# Vibration/Tapping and/or Misfire After Cold Soak

YEAR(S)	MODEL(S)	ADDITIONAL INFORMATION
2013 - 2016	CT200H

Some 2013 – 2016 model year CT 200h vehicles may exhibit a vibration due to a rough idle and/or tapping noise from the HV transaxle after cold soak. The check engine light may also illuminate with Diagnostic Trouble Codes (DTCs) P0300, P0301, P0302, P0303, or P0304 (Random/Multiple Cylinder Misfire Detected). The Engine Control Module/ECM (SAE Term: Powertrain Control Module/PCM) logic has been modified to reduce the possibility of this condition occurring. Follow the Repair Procedure in this bulletin to address this condition.

Figure 1. Location of Authorized Modification Label on 2013 – 2016 CT 200h

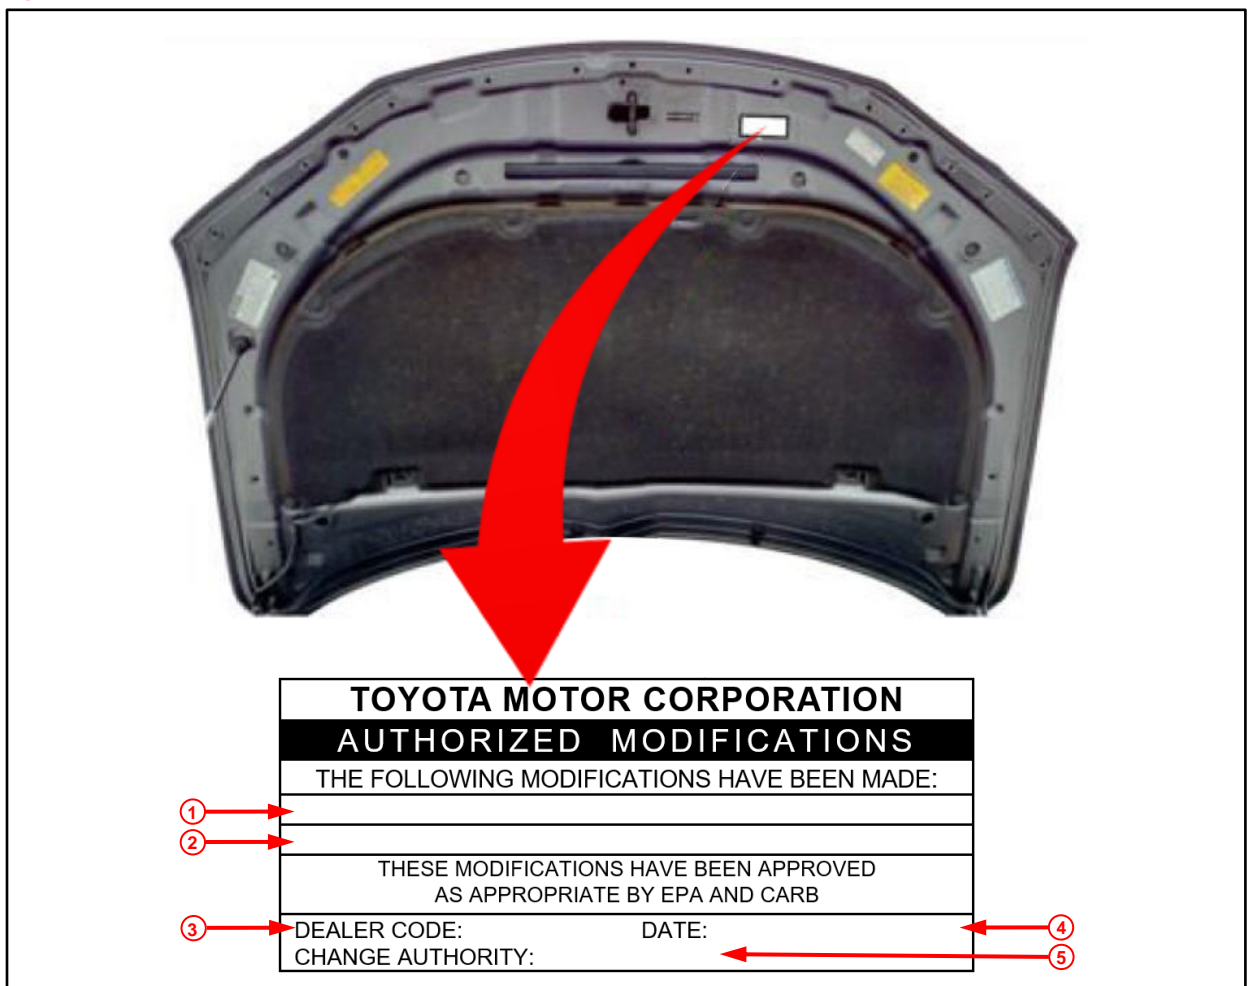
2. Check for the Authorized Modification Label affixed to the vehicle in the location shown below. Confirm if the ECM (PCM) calibration has been updated. Is the ECM (PCM) calibration the most recent calibration?
  - **YES** — This bulletin does NOT apply. Continue diagnosis using the applicable Repair Manual.
  - **NO** — Continue to step 3.

4. Prepare and install the Authorized Modification Label.
  - A. Using a permanent marker, enter the following information on the label:
    - ECM part number [Refer to the **Parts Information** section for the **NEW PART NUMBER**]
    - Calibration ID(s) [Refer to the **Calibration Information** section for the **NEW CALIBRATION ID**]
    - Dealer Code
    - Repair Date
    - Change Authority [**This bulletin number**]
  - B. Install the Authorized Modification Label on the vehicle at the location shown in Figure 1. The Authorized Modification Label is available through the MDC, P/N 00451-00001-LBL.
5. Confirm the repair.
  - A. Verify the vehicle no longer exhibits vibration/tapping and/or misfire condition AFTER cold soak.
  - B. Test drive the vehicle to confirm proper vehicle operation.
